Item Name: Crosstube Aft

DART AEROSPACE LTD		Work Order:	85315
Description: Crosstube High Aft (407)		Part Number:	D407-667-205
Inspection Dwg: D407-667-245 Rev: F		Page 1 of 1

DRAWING NO. D407-667-245	TITLE CROSSTUBE ASSY (407 HIGH AFT)	REV. F	DART AEROSPACE LTD ENGINEERING ORDER	D.E.O. NO. D407-667-245-F-1	SHEET NO. SHEET 2 OF 2	SCALE NTS
DRAWN	CHECKED	MFG. APPR.	APPROVED	DE APPR.		
DATE 11.04.08	DATE 11.04.11	DATE 11.04.12	DATE 11/04/12	DATE 11-04-12

DRAWING NO. D407-667-245	TITLE CROSSTUBE ASS'Y (407 HIGH AFT)	REV. F	DART AEROSPACE LTD ENGINEERING ORDER		D.E.O. NO. D407-667-245-F-2	SHEET NO. SHEET 1 OF 1	SCALE NTS
DRAWN 92	CHECKED ASS	MFG. APPR. E	APPROVED MP		DE APPR. H		
DATE 11.09.07	DATE 11.09.19	DATE 11.09.19	DATE 11.09.19		DATE 11.09.19

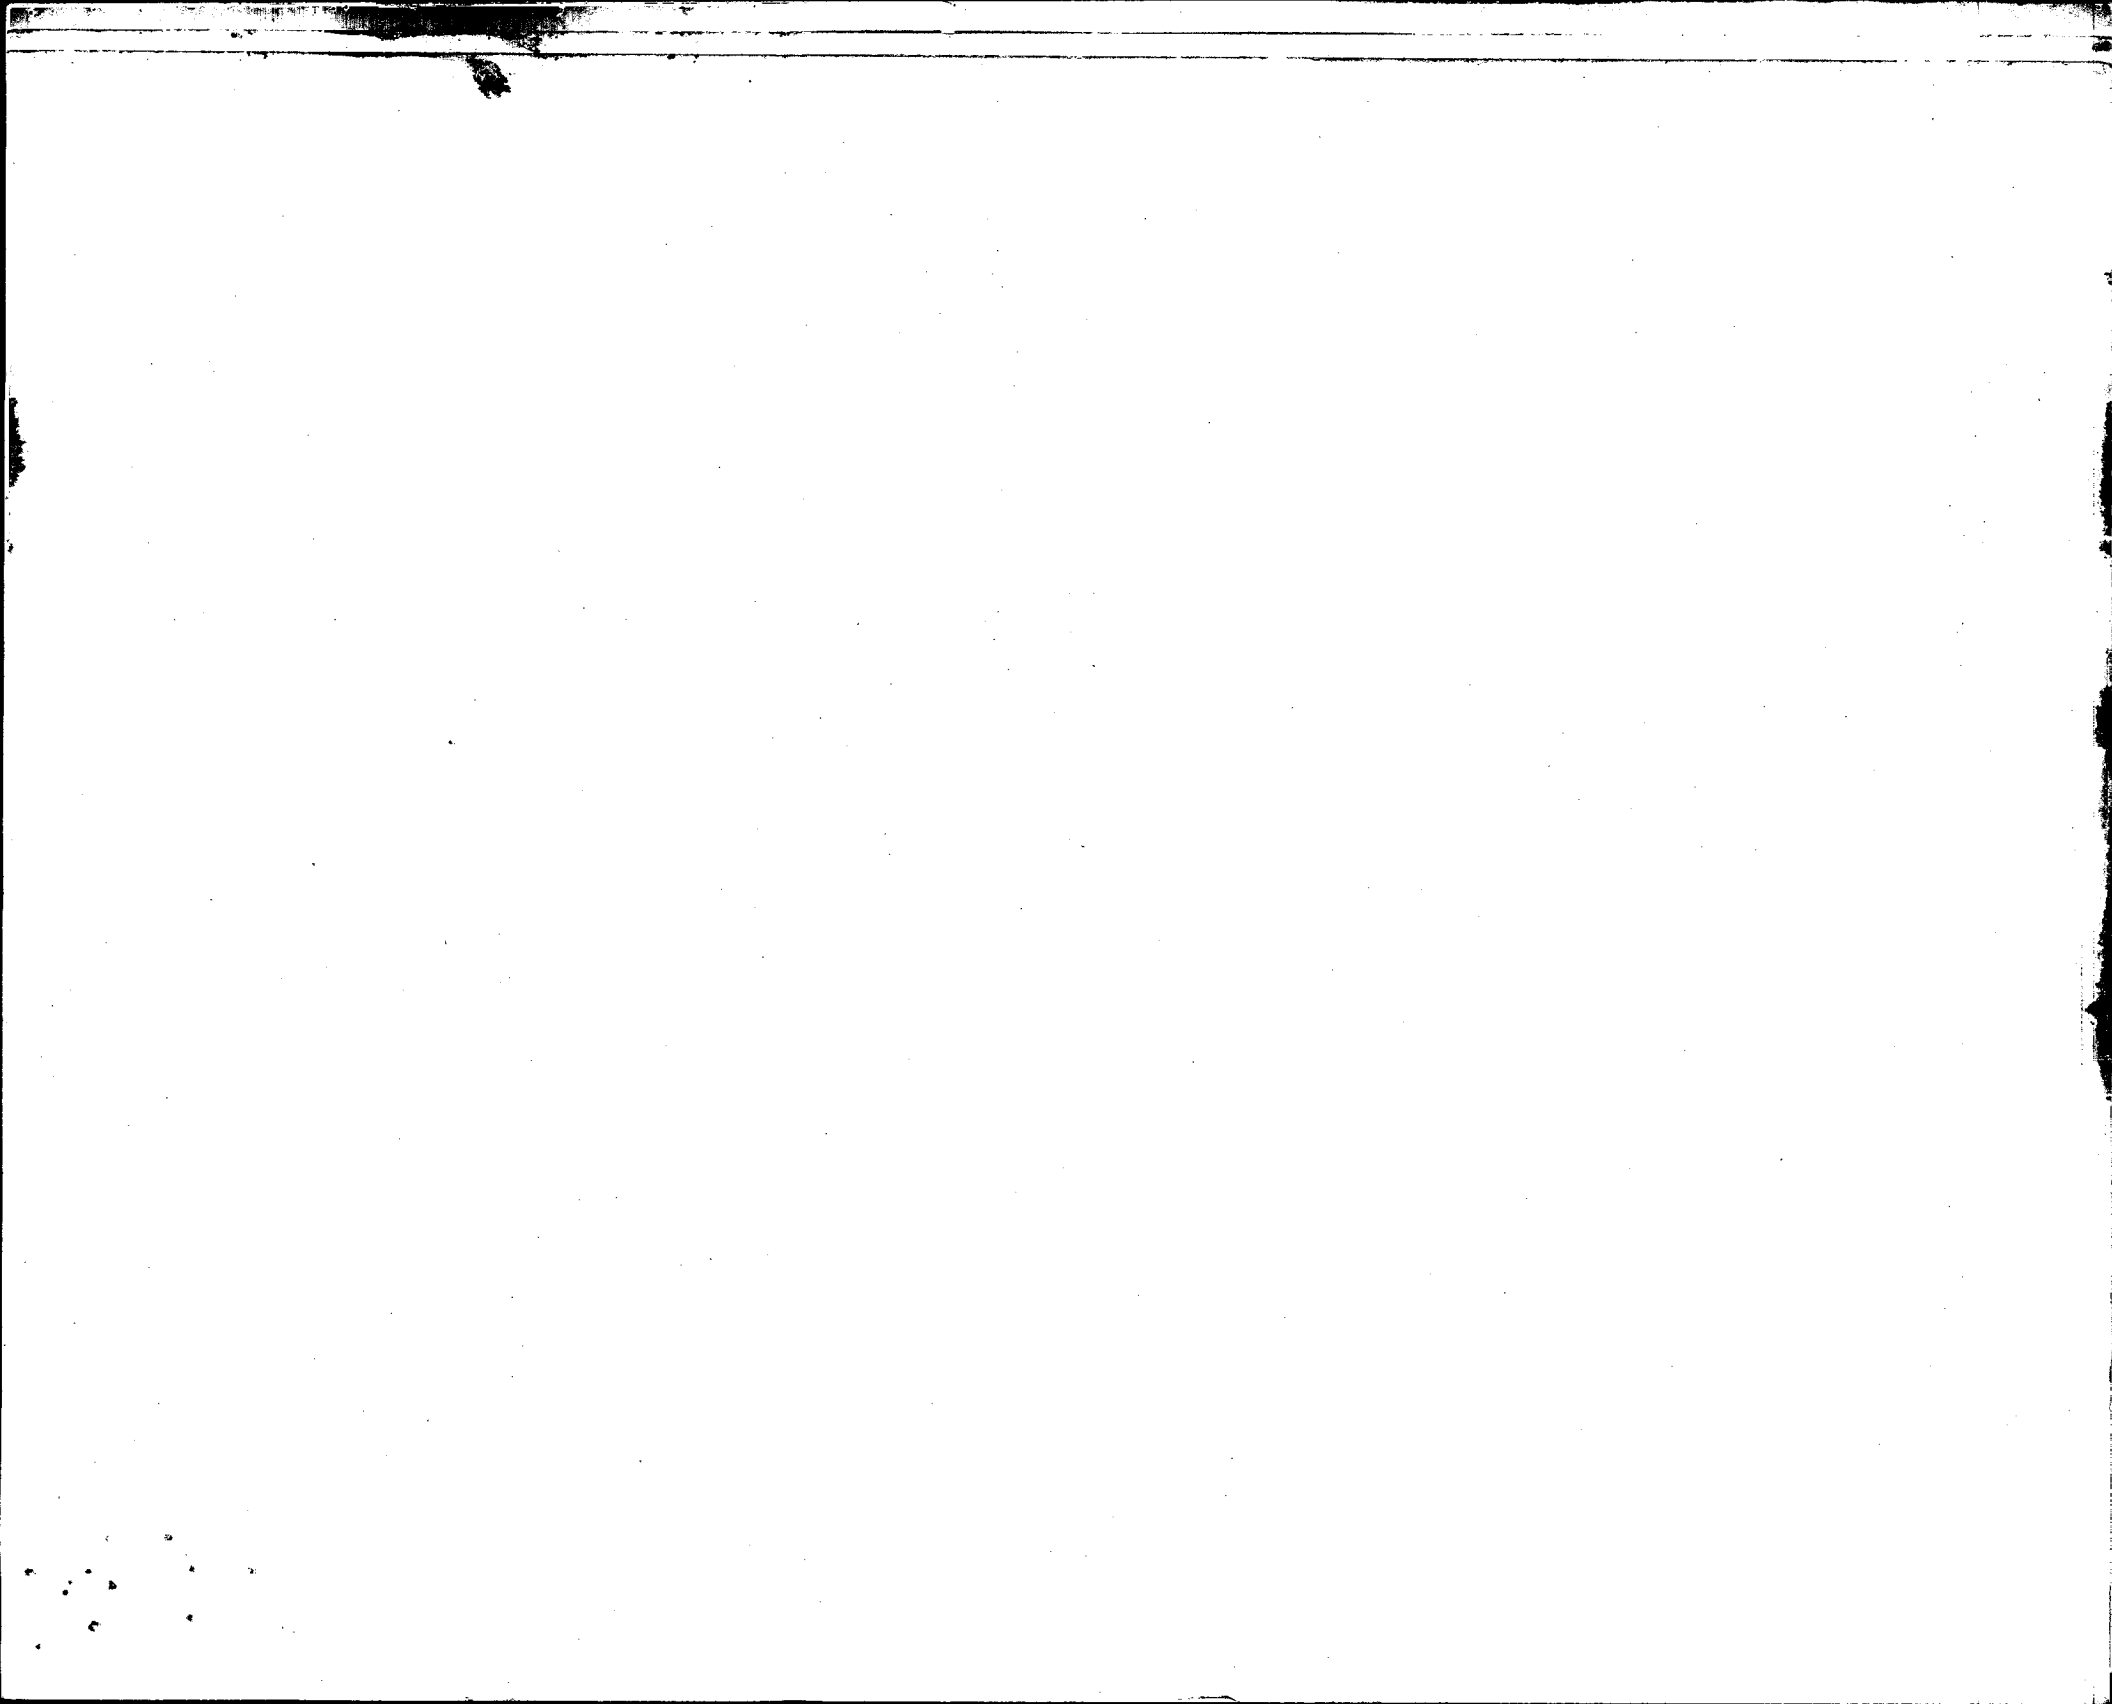
IS:

WAS:

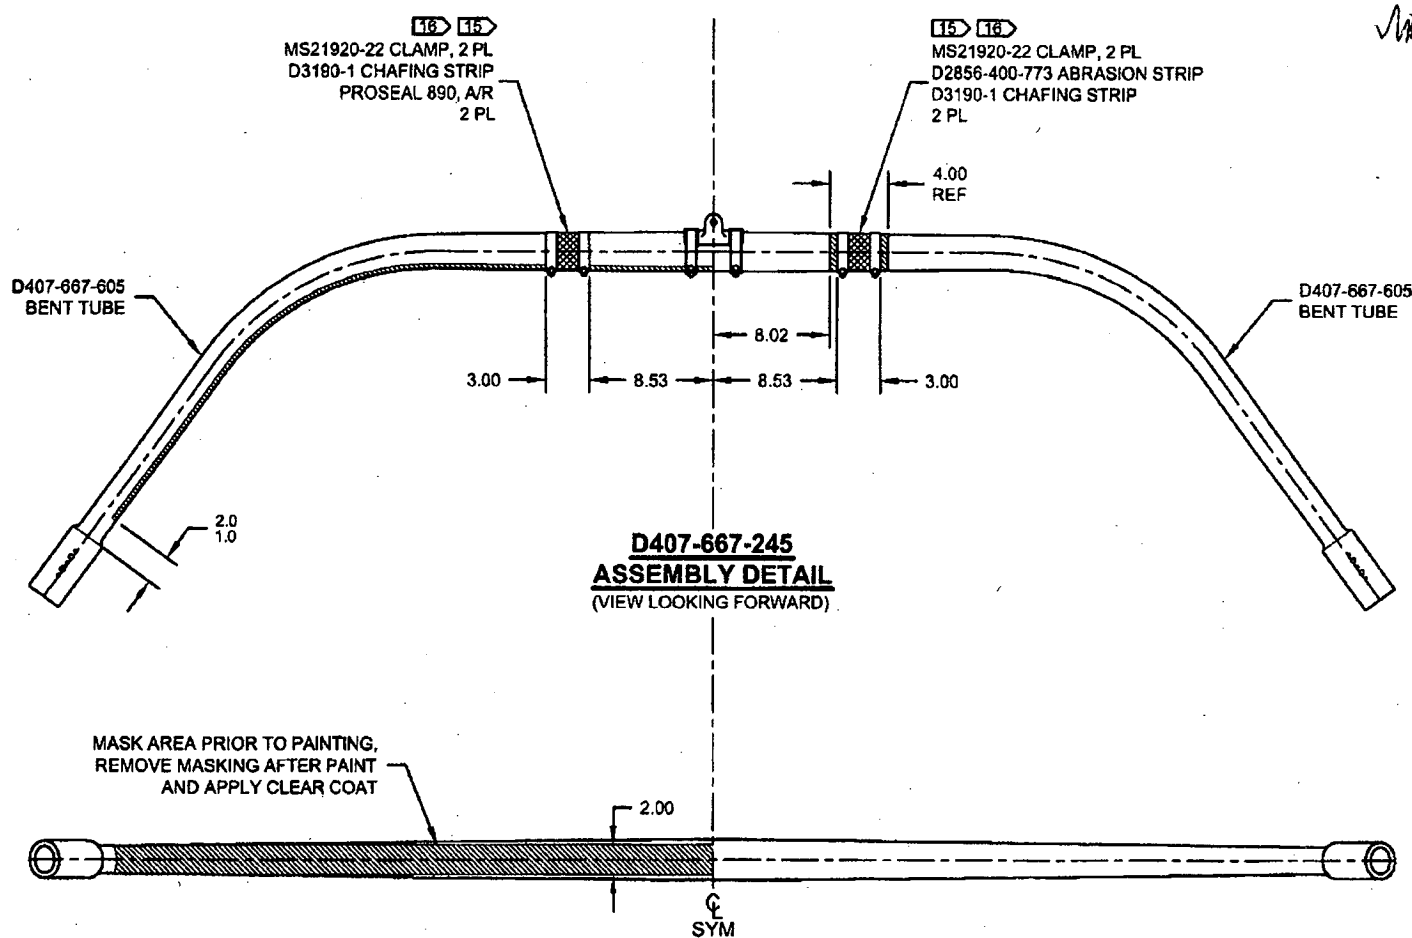
REPLACE MAGNOBOND WITH 3M DP460 SCOTCH-WELD EPOXY ADHESIVE

NOTE 12 & 17, SHEET 1 IS AMENDED AS FOLLOWS:
